Adjacent Channel Spectral Isolation definition for 802.3cw – Supporting comment # 251 on D2.1

IEEE P802.3cw

June, 2023

CI 156 SC 156.9.31 P 104 L 14 # 251

Figure 156-3—Black link example configuration for specifying n DWDM channels

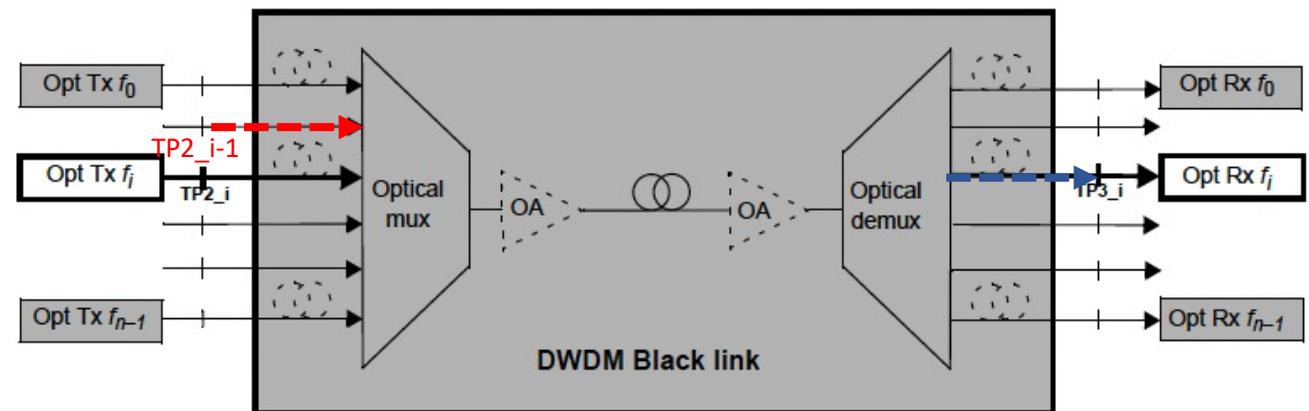
Adjacent Channel Spectral Isolation needs additional definition.

TBD in this subclause needs to be replaced with a definition. The commenter will bring in a contribution with a proposed definition.

- Filter parameters are used to calculate the adjacent channel isolation in a black link approach
- The following parameters for Mux & Demux are used to derive the DWDM black link adjacent channel spectral attenuation:
 - BW max = 76GHz
 - Filter order = 3
 - |Center frequency variation| \leq 4 GHz
 - Insertion loss variation \leq 1.5dB
 - Adjacent channel floor = -30dB

The adjacent channel spectral isolation is specified in Table 156-9. The frequencies in Table 156-9 refers to the offset from the center frequency for channel n , f_n . The isolation in Table 156-9 specifies the power received at TP3 _{n} at the specified frequency for light transmitted into an adjacent channel, TP2 _{$n\pm 1$} , divided by the power received at TP3 _{n} for light at the same optical power at the center frequency f_n transmitted into TP2 _{n} .
